TECHNICAL BULLETIN

DATE: 9 FEBRUARY 2011

*Supersedes Technical Bulletin TB900-034, dated 25 June 2010. Revised to add and change part numbers for replacement parts and supplies and to change rework instructions.

THRUSTER ASSEMBLY MODIFICATION

Figure 1. Thruster Assembly

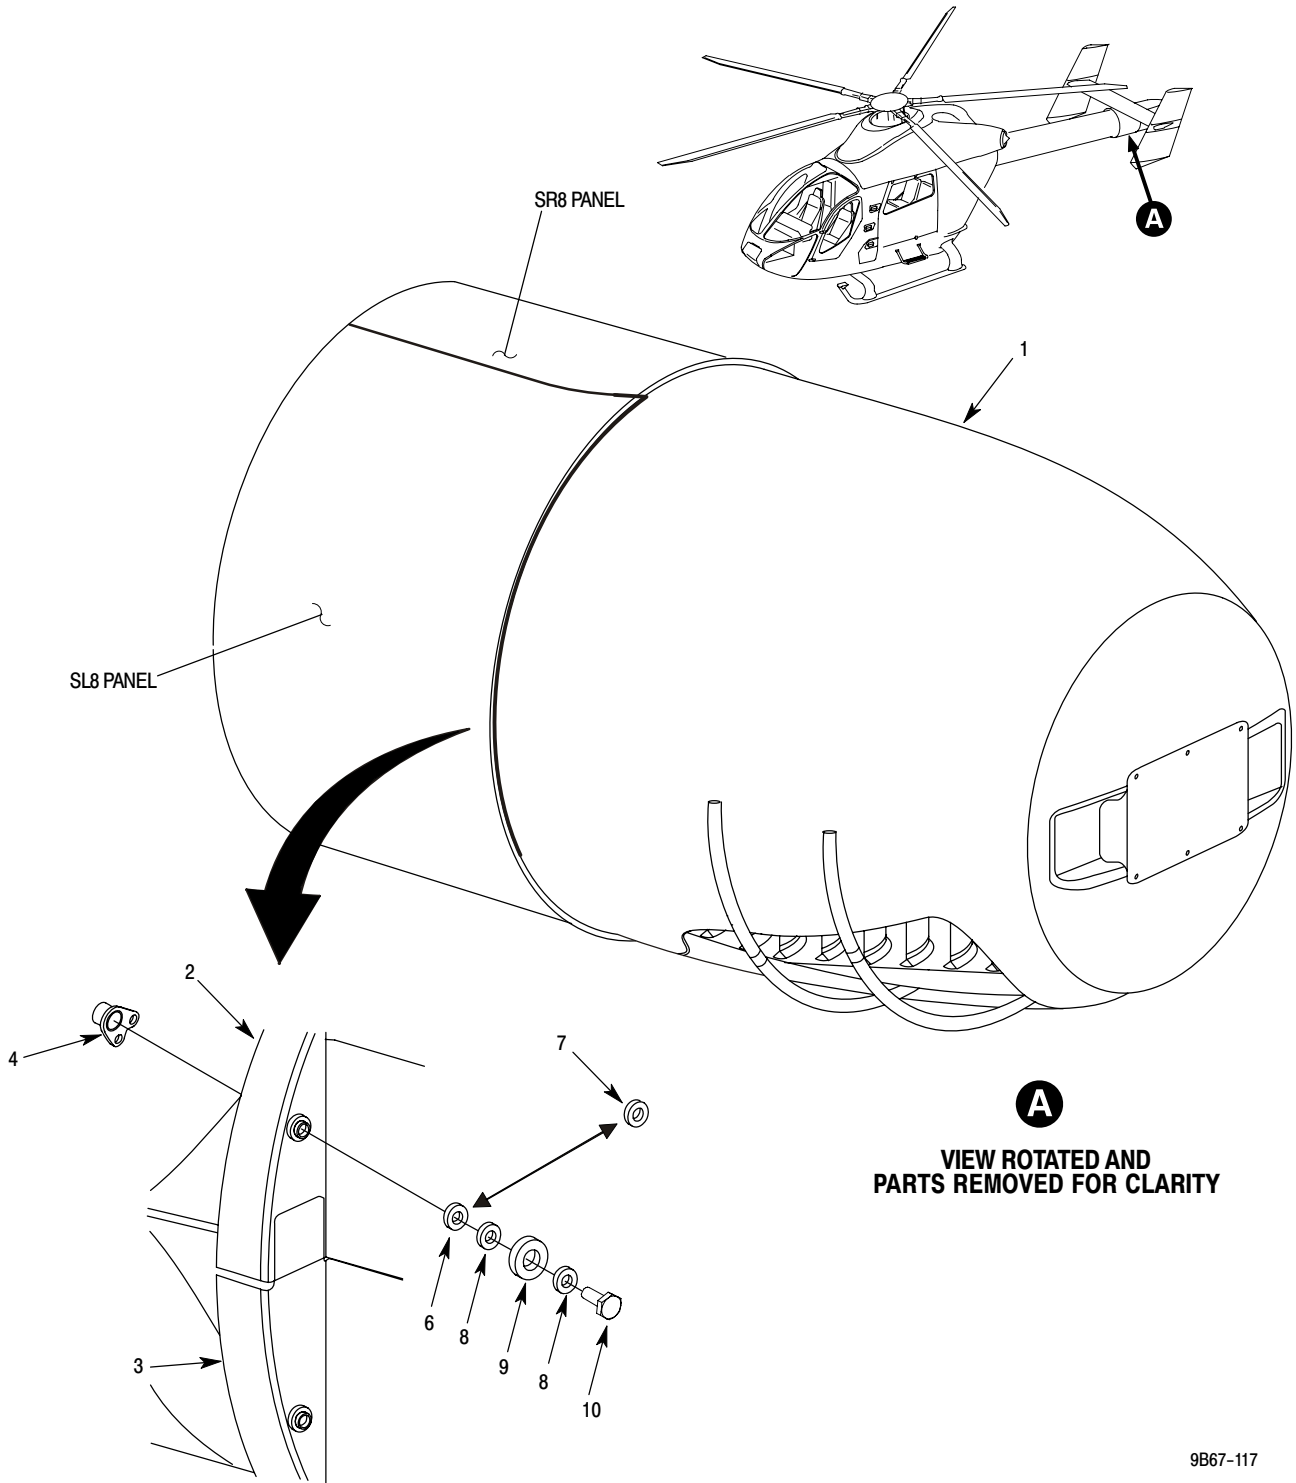
- (1). Remove the SL8 and SR8 thruster extension fairing assemblies (ref. CSP-900RMM-2, 53-40-00, Maintenance Practices, and Figure 1).
- (2). Remove the thruster rotating cone cover (ref. CSP-900RMM-2, 67-20-00, Removal/Installation).

- (3). Remove the rotating cone assembly (ref. CSP-900RMM-2, 67-20-00, Removal/Installation).
- (4). Examine the bearing track surface on the inside of the bearing race of the rotating cone assembly (1) for cracks and too much wear.

- (a). The maximum wear depth that is permitted is **0.001 to 0.003 inch (0.03 to 0.08 mm)** (ref. CSP-900RMM-2, 67-20-00, Inspection/Test/Rigging).
 - 1). If the wear is in the specified limit, blend wear indentations or sharp edges with a crocus cloth.

- 2). If the wear is more than the specified limit, replace the bearing race of the rotating cone assembly (1) (ref. CSP-900RMM-2, 67-20-00, Removal/Installation).

- (b). Replace the bearing race of the rotating cone assembly (1) if there are cracks (ref. CSP-900RMM-2, 67-20-00, Removal/Installation).

Figure 2. Location of 16 Control Bearings

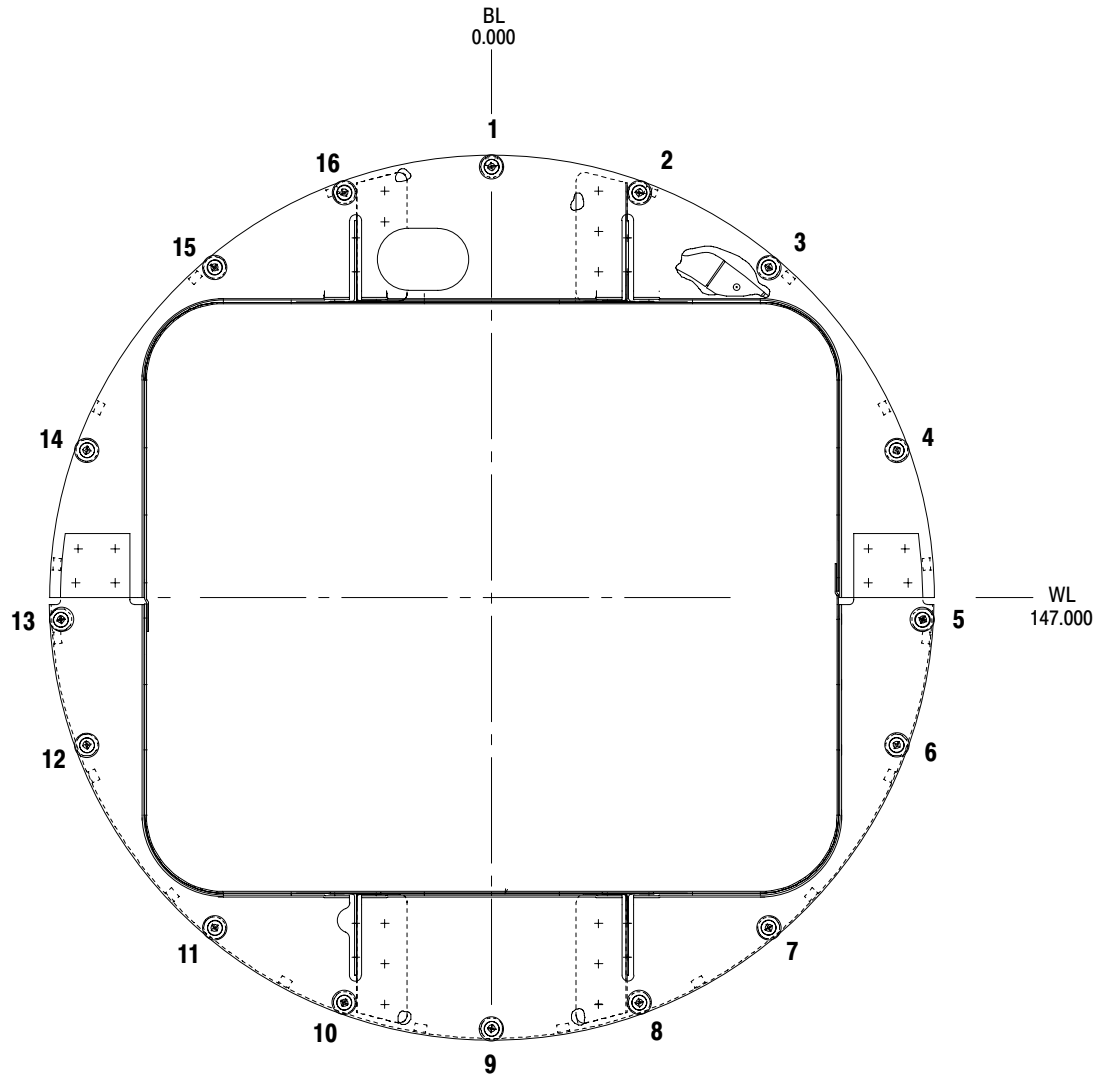
- (1). Remove bolts (10), control bearings (9), flat washers (8), and nylon washers (6) at locations 2, 4, 6, 8, 10, 12, 14, and 16 (ref. Figure 2).

The rivets and nutplates at locations 2, 4, 6, 8, 10, 12, 14, and 16 must be removed and discarded. Unrestrained and installed nutplates can cause foreign object damage (FOD).

- (2). Remove rivets (5) and nutplates (4) at locations 2, 4, 6, 8, 10, 12, 14, and 16.
 - (a). Discard rivets (5) and nutplates (4).
- (3). Repair holes from removed nutplates:

Figure 3. Location of 24 Control Bearings

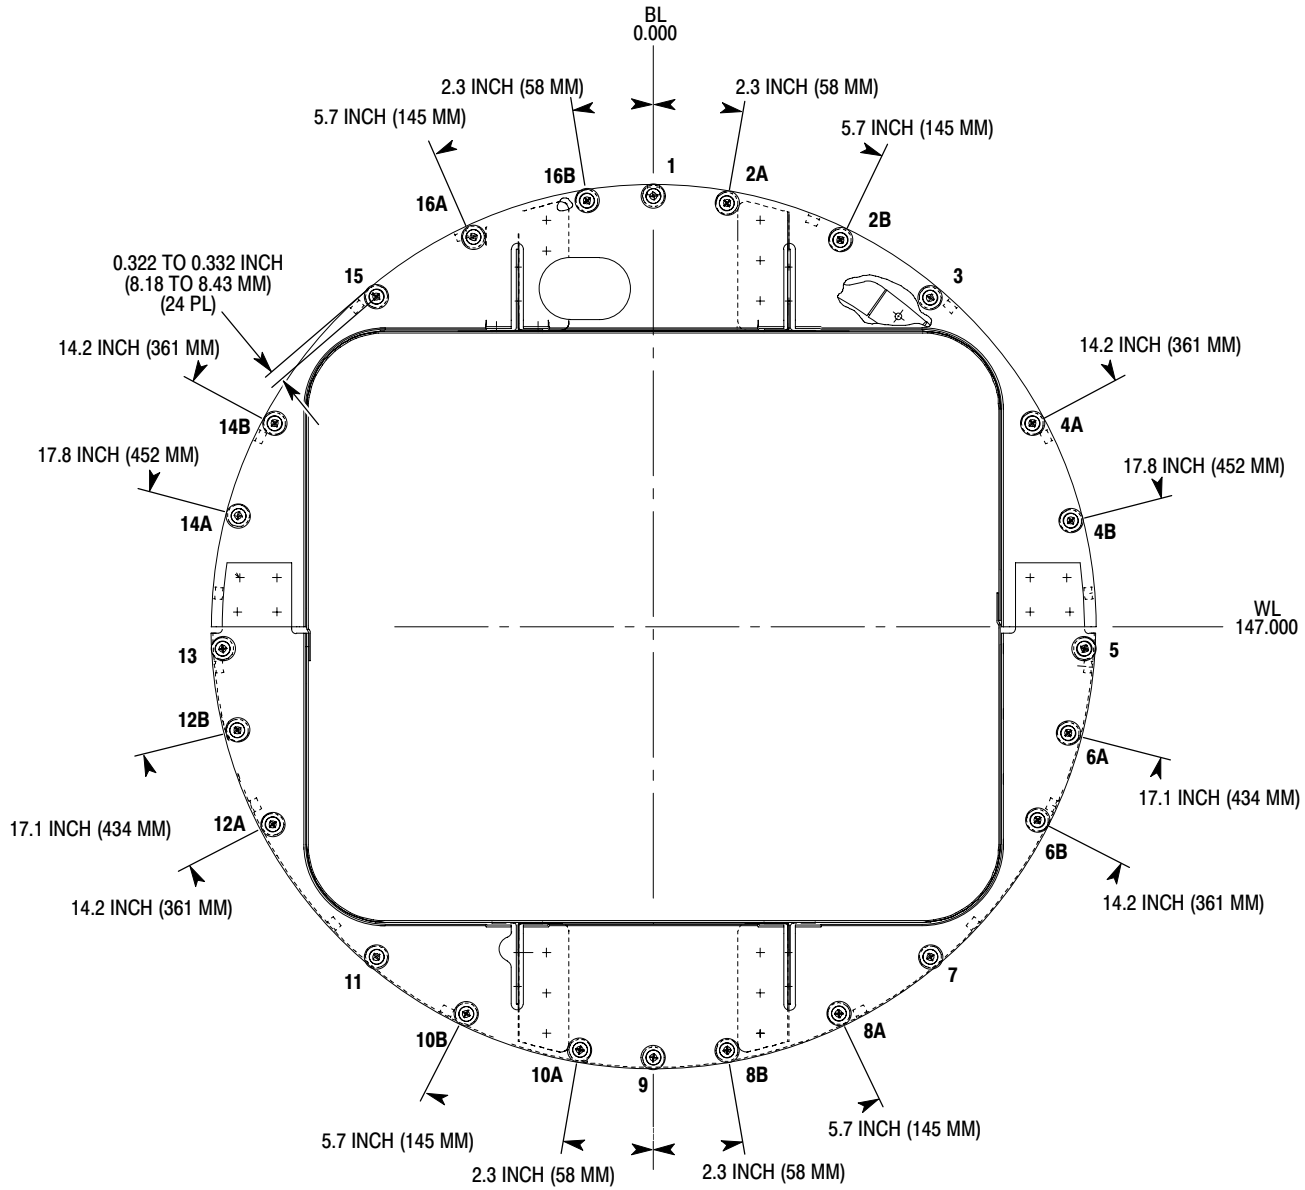
- (z). Deleted.
- (aa). Deleted.
- (4). Find new bolt holes at locations 2A, 2B, 4A, 4B, 6A, 6B, 8A, 8B, 10A, 10B, 12A, 12B, 14A, 14B, 16A, and 16B (ref. Fig. 3) with MD900 stationary thruster bearing hole location tool (PN 900F2421510-107-DJ1), tape measure, and C-clamps. (Ref. Figure 3 and Figure 4.)

- (8). Install CRES washers (7), flat washers (8), control bearings (9), and bolts (10) at locations 2A, 2B, 4A, 4B, 6A, 6B, 8A, 8B, 10A, 10B, 12A, 12B, 14A, 14B, 16A, and 16B.
 - (a). Torque bolts **15 to 20 in-lb (1.7 to 2.3 Nm)**.
 - (b). If necessary, to remove remaining axial play of the stack-up, torque bolts to **24 in-lb (2.7 Nm)** maximum.

- (9). Remove and replace nylon washers (6) with CRES washers (7) at locations 1, 3, 5, 7, 9, 11, 13, and 15 (ref. Figure 1 and Figure 3).
 - (a). Remove bolts (10), control bearings (9), flat washers (8), and nylon washers (6).

Figure 4. Find And Drill New Holes With The Location Tool

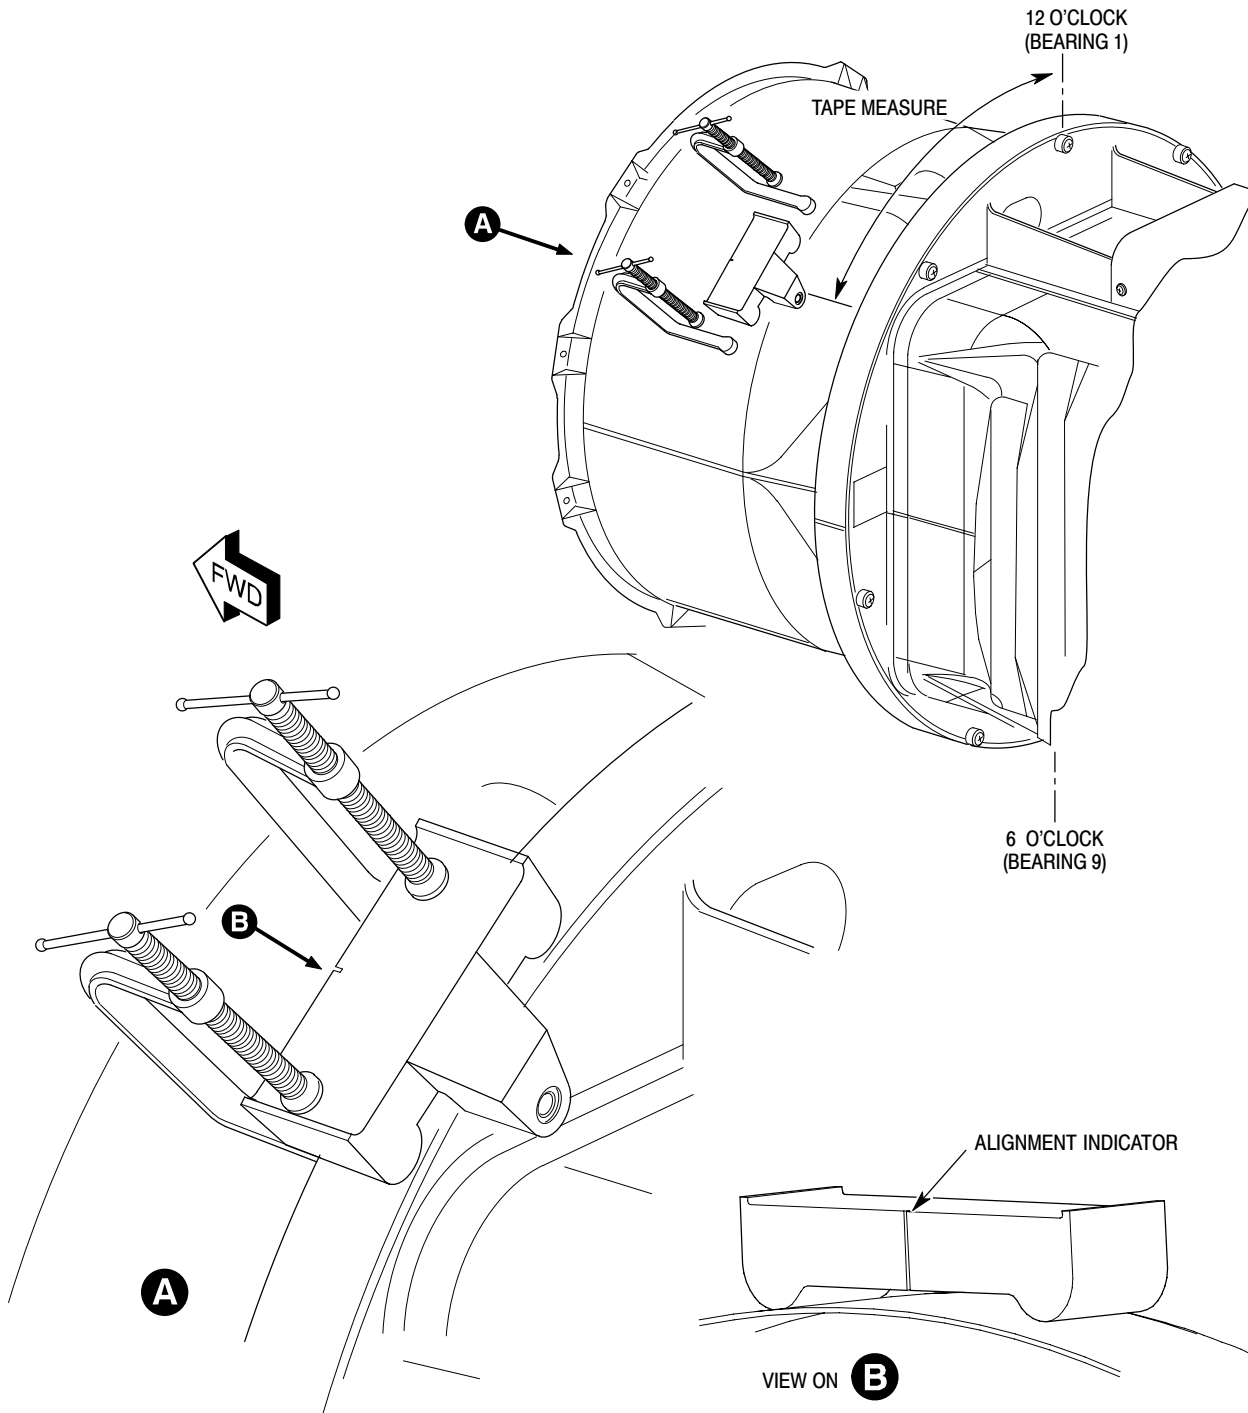
- (5). Drill 16 **0.190 to 0.193 inch (4.83 to 4.90 mm) diameter** bolt holes with MD900 stationary thruster bearing hole location tool (PN 900F2421510-107-DJ1), C-clamps and a spade bit at locations 2A, 2B, 4A, 4B, 6A, 6B, 8A, 8B, 10A, 10B, 12A, 12B, 14A, 14B, 16A, and 16B. (Ref. Figure 4.)
